Airworthiness Concern Sheet

Make, Model, Series, Serial No.: Taylorcraft, all models equipped with landing gear.

Reason for Airworthiness Concern: Failure of the Main Landing Tie Strut, Part Number B-A51

SUBJECT: Drain hole - landing gear tie strut.

FIG. 1.

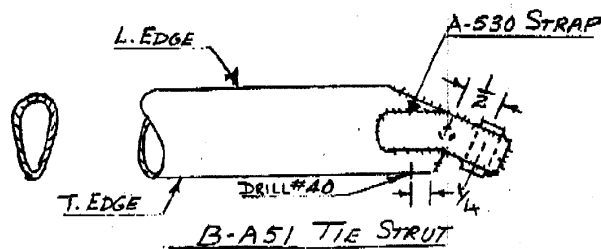
COMPLIANCE PROCEDURE: (1) Inspect landing gear tie strut (TAC P/N B-A51) near "bolt" at axle for obstruction or foreign material in drain hole

Note that drain hole is either located at center of strap (TAC P/N A-530) and/or at trailing edge of tie strut. Only one hole is sufficient for drainage.

(2) If drain hole(s) is (are) plugged, open with suitable means.

(3) If none of the drain holes exist, drill #40 in trailing edge as shown in Fig. 1.
